TECHNICAL BULLETIN

Revision Of The 3510 Receiver Top

Bulletin #:	Rev:	Created by:	Date:
00-116136-0	A	JGPB	15-01-2018

ECR # **26072** Production: - Service: - Sales: X
Product Lines: Transportation Equipment: - Agri-vac/Pneumatic Equipment: X

RECEIVER TOP, INST, 3510 (11-68171-5)

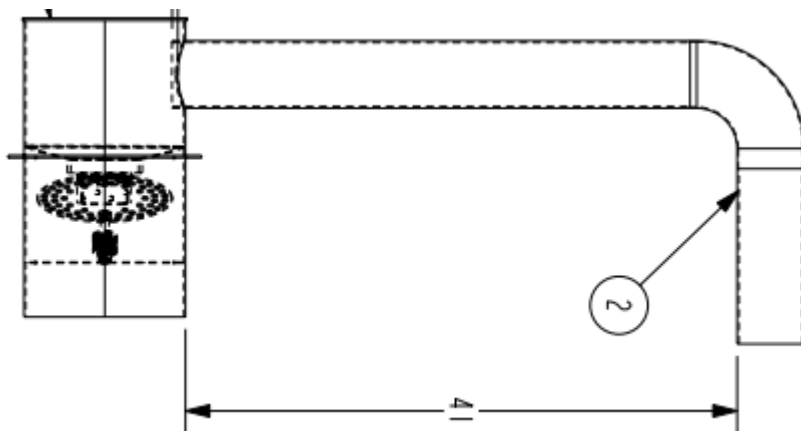
Walinga has modified all 3510 receiver tops. The top of the 3510 has been extended in order to improve manufacturing efficiency. With this change, a filler pipe is no longer required. This pipe was installed in order to make the inlet pipe match up and fit, however it also caused some obstruction to the airflow. By extending the top an elbow has been removed from blower piping. (51-91362-6)
